PLANNING AND ZONING COMMISSION AGENDA-SPECIAL MEETING

STAFF REPORT
KETCHUM PLANNING AND ZONING COMMISSION
SPECIAL MEETING OF MARCH 27th, 2018

PROJECT: Bigwood Square Retail/Mixed-Use Building

FILE NUMBER: #18-030

A 2.0

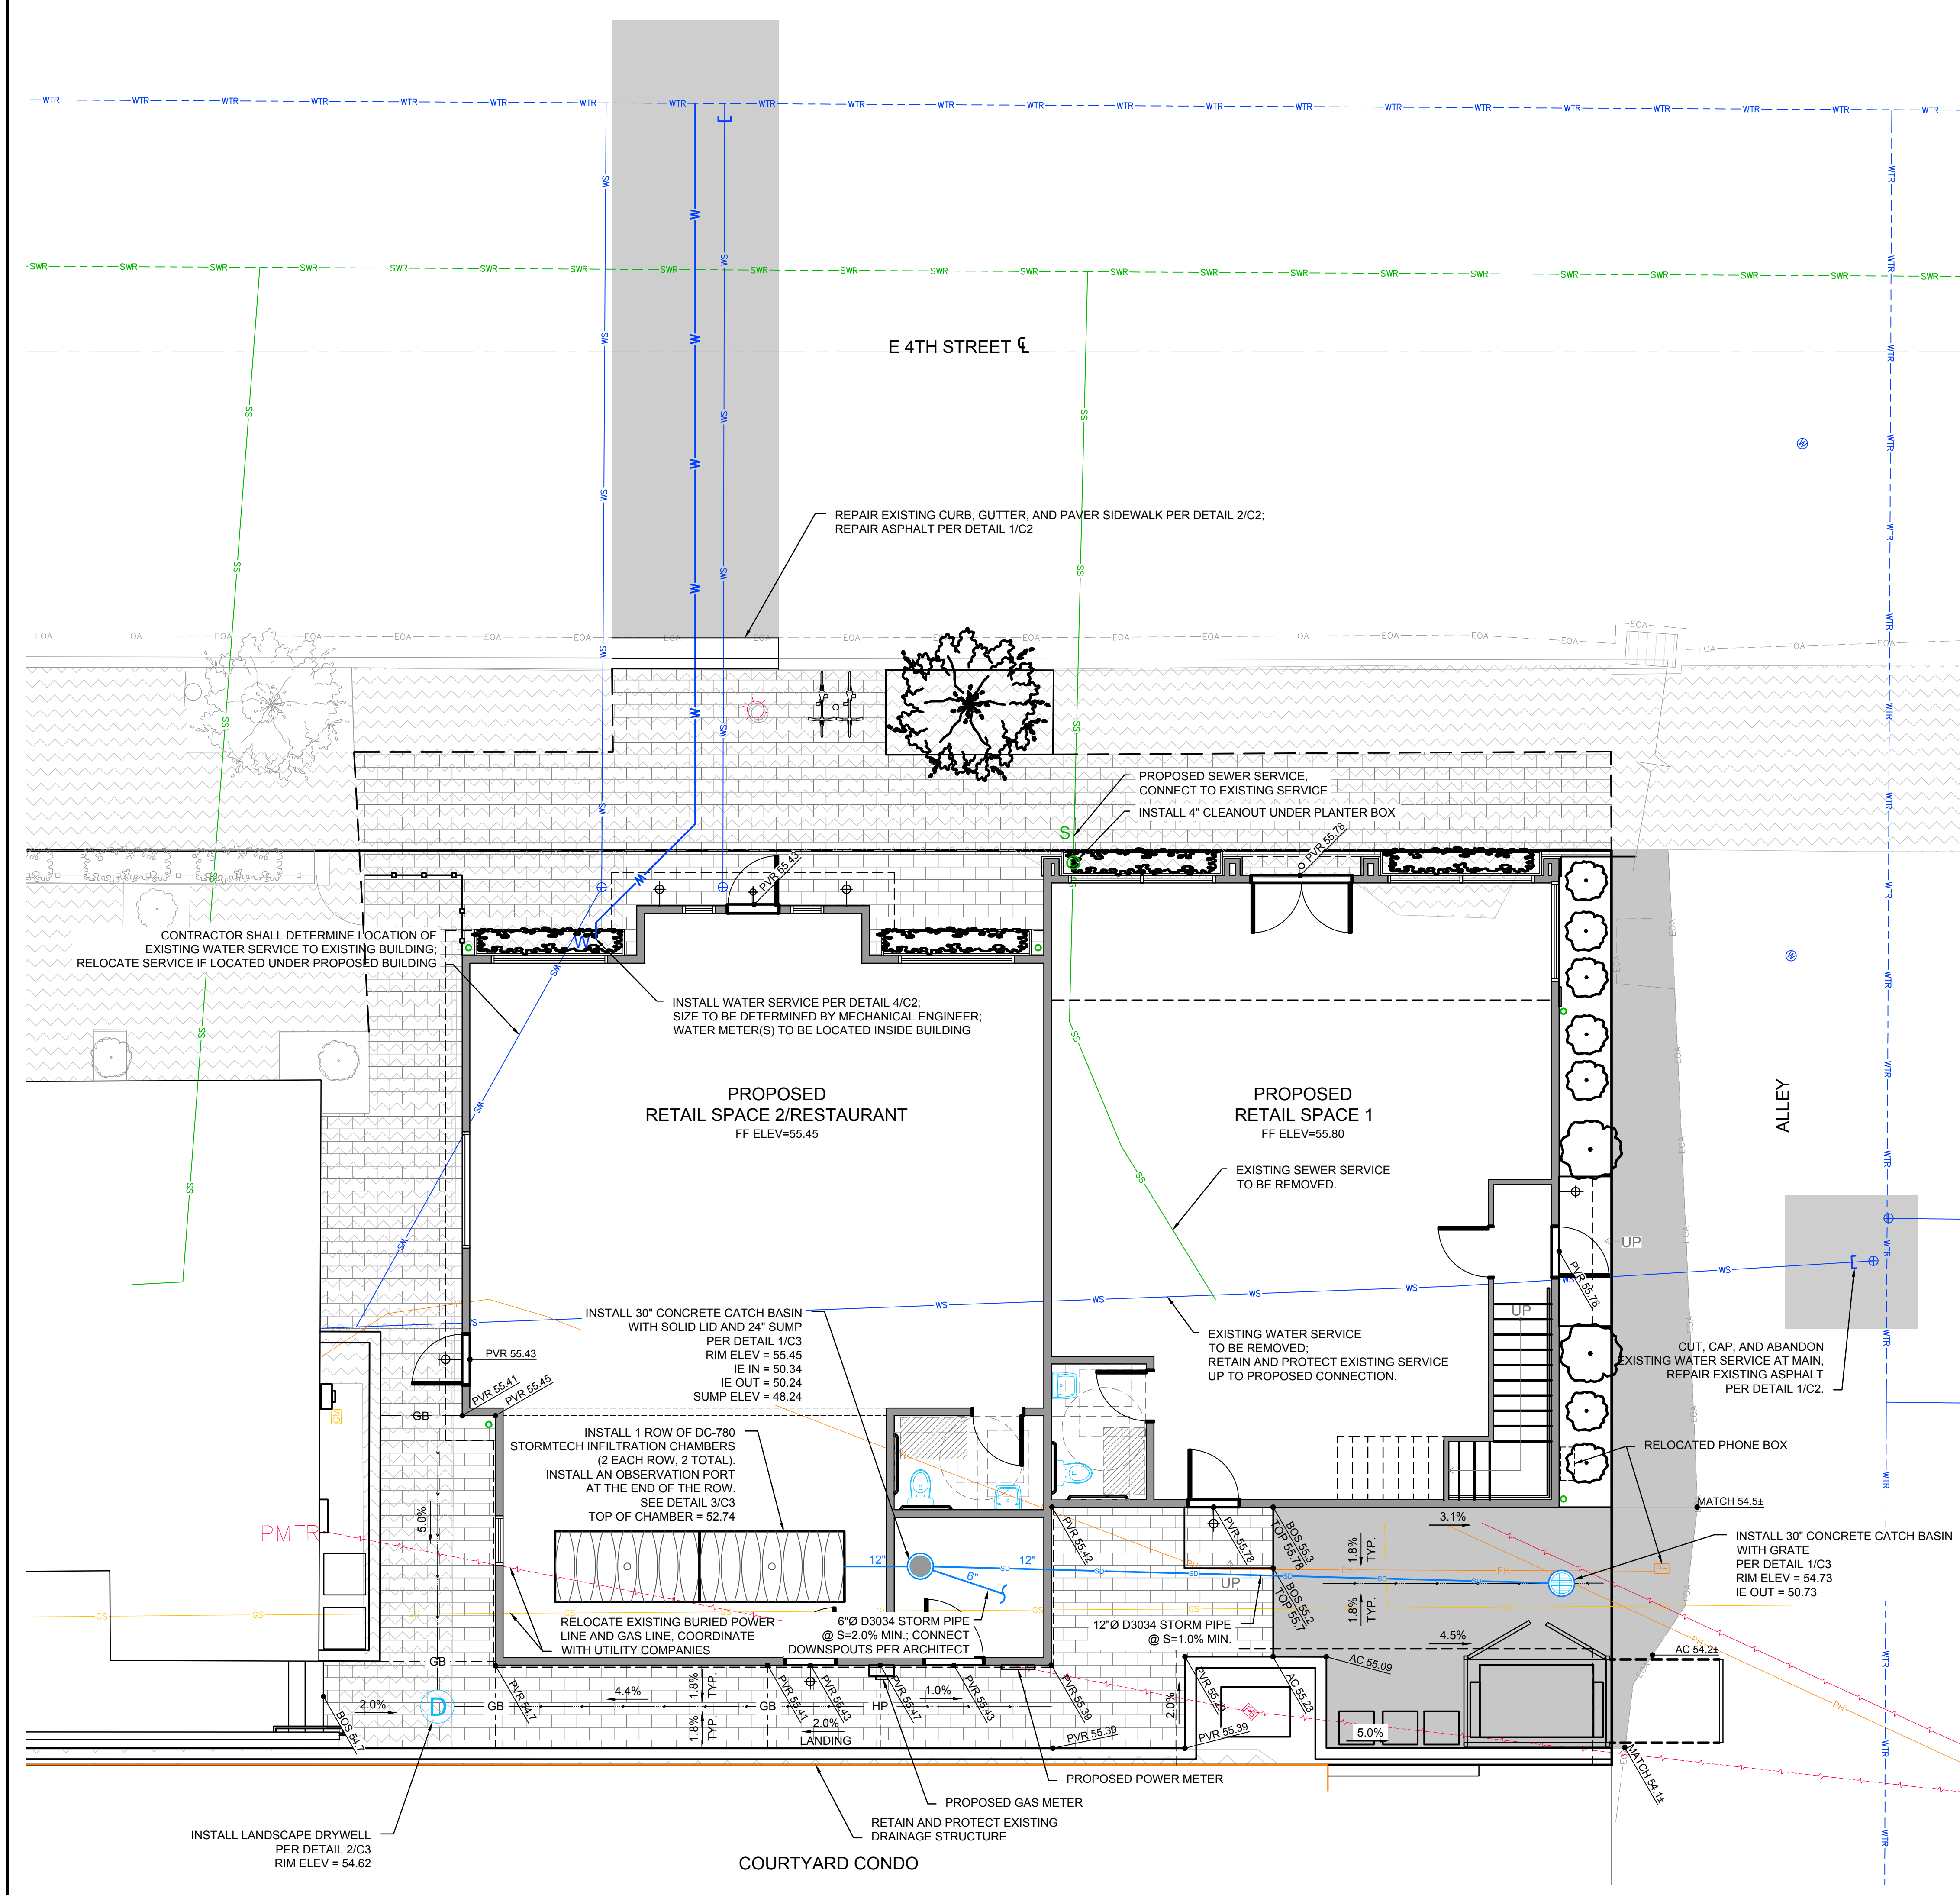
<i>Staff Comments</i>	<i>Sheet A3.0 indicates that snow retention bars will be installed on all sloped roofs. The snow retention devices in conjunction with gutters and downspouts will prevent water to drip or snow to slide on areas where pedestrians gather and circulate. Roof overhangs do not extend over the proposed areas for pedestrian circulation.</i>
<input checked="" type="checkbox"/>	<input type="checkbox"/>	<input type="checkbox"/>	17.96.060(G)(1)	Pedestrian, equestrian and bicycle access shall be located to connect with existing and anticipated easements and pathways.
			<i>Staff Comments</i>	<i>The existing pedestrian access connects with adjacent, existing sidewalks and pathways. There are no existing or anticipated easements on the site as the public entrances to the restaurant and retail spaces are accessed from the sidewalk on E. 4th Street.</i>
<input type="checkbox"/>	<input type="checkbox"/>	<input checked="" type="checkbox"/>	17.96.060(G)(2)	Awnings extending over public sidewalks shall extend five (5') feet or more across the public sidewalk but shall not extend within two (2') feet of parking or travel lanes within the right of way.
